Proposal for a new Supplement to the 06 series of amendments to UN Regulation No. 49 (Emissions of compression ignition and positive ignition (LPG and CNG) engines)

Submitted by the expert from the International Organization of Motor Vehicle manufacturers

Part 1) - Amendments to ANNEX 4, in line with Japanese document ECE/TRANS/WP.29/GRPE/2021/7 as modified by Informal Document GRPE-82-09

“A.2.1.3. Components of Figures 9 and 10

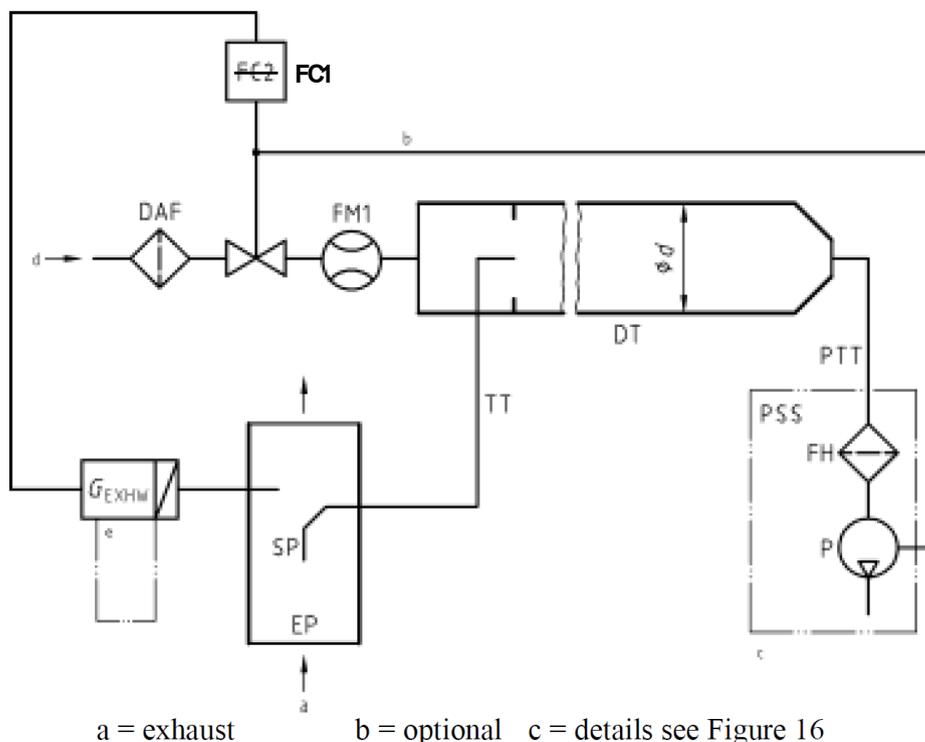
Paragraph A.2.1.3., amend to read:

In Figure 9, raw exhaust gas sampling probe is represented by “SP1”, whereas “SP” is indicated in the text. Therefore, it is necessary correctly set “SP1” in the text.

SP1 Raw exhaust gas sampling probe (Figure 9 only)
